Product Change Notice

Issue Date: September 23, 2019

Add ASE Taiwan as Bump supplier

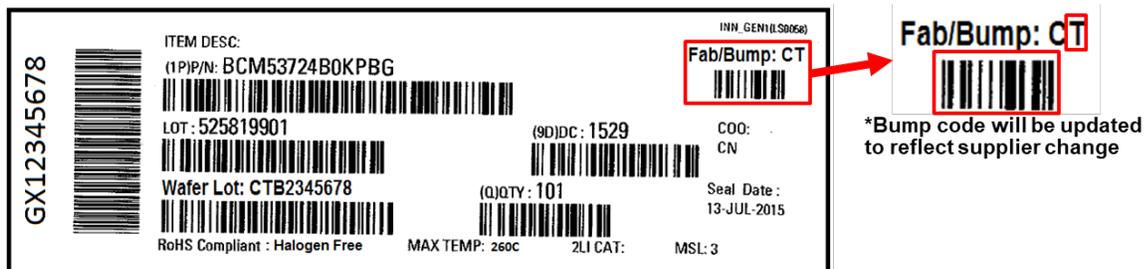
Additional CuP Bump supplier - ASE TAIWAN
